Product Change Notification

113473 - 00

Change Notification #: 113473 - 00
Change Title: Intel® Server System R2308GZ4GC,
PCN 113473-00, Product Design,
Update Resistors and Capacitor
Date of Publication: December 2, 2014

Figure One. Component Locations for the 2U Riser Spare A2UL8RISER

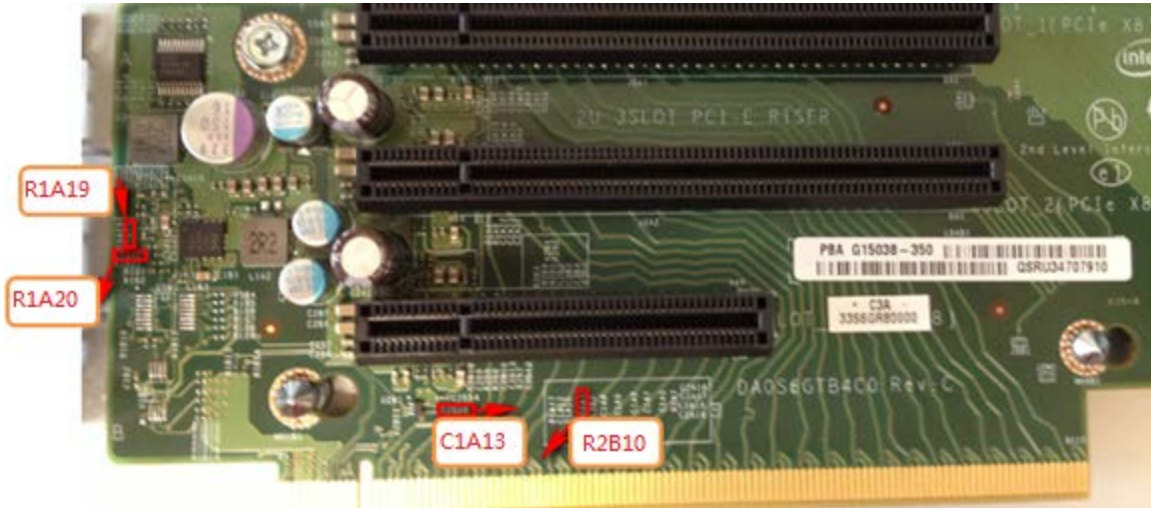
- Update the following resistors and capacitor (see Table One and Figure Five) on the 2U PCIe Riser Spare A2UL8RISER to make an improvement to support a higher 3.3 Voltage Regulator startup over current. Before this change, the Voltage Regulator on the riser card may not be able to turn on when the total current drawn is more than 5A current. After this change, the Voltage Regulator on the riser card can support more than 10A current.

Component	Location	Pre-change	Post-change
Resistor	R2B10	10.00 kOhm	3.65 kOhm
Resistor	R1A20	0 Ohm	30 Ohm
Resistor	R1A19	40.20 kOhm	20.00 kOhm
Capacitor	C1A13	10.00 pF	120.00 pF
